Report: TAB Report
Function: Test, Adjust, & Balance
Date: 03/12/2026
Completed By: National TAB

PROJECT
02-02-26 QT #1430 SURPRISE, AZ

Project: 02-02-26 QT #1430 SURPRISE, AZ

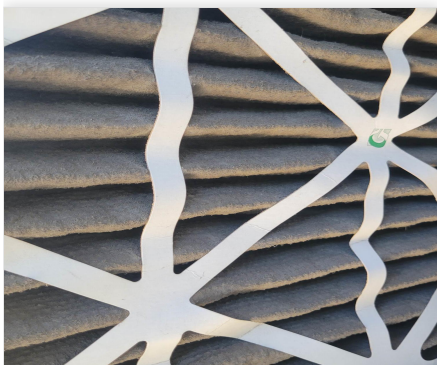
Issue Name : EF3 CURB LEAK
Description : Fan is set for higher than normal, yet flow is too low. Losing quite a bit of air due to improper flange installation at curb.
Created By : National TAB **Assigned To :** National TAB - Dan Hertenstein
Status : Open
Priority : Urgent **Asset Tag :** EF3
Originated Date : 02/25/2026 - Christine Weale - National TAB

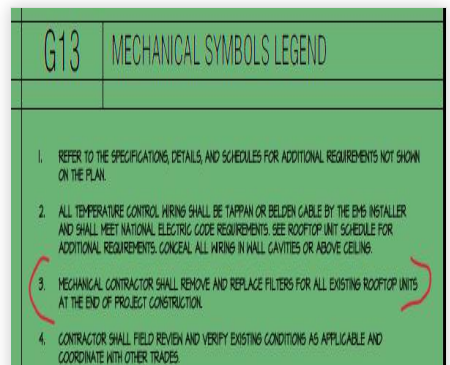
Issue Name : EXTREMELY DIRTY FINAL FILTERS
Description : ALL UNITS: See pics
Created By : National TAB **Assigned To :** National TAB - Dan Hertenstein
Status : Open
Priority : Low **Asset Tag :**
Originated Date : 03/12/2026 - Christine Weale - National TAB

Asset: EF3

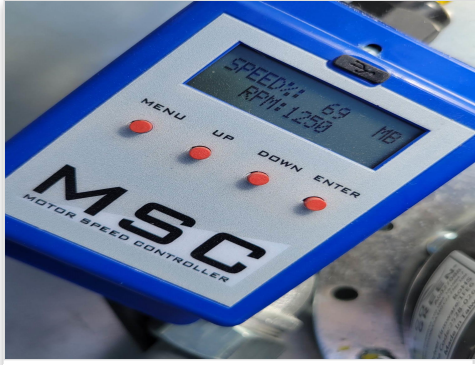
Notes:
LEAK AT CURB, SEE 'REMARKS'.
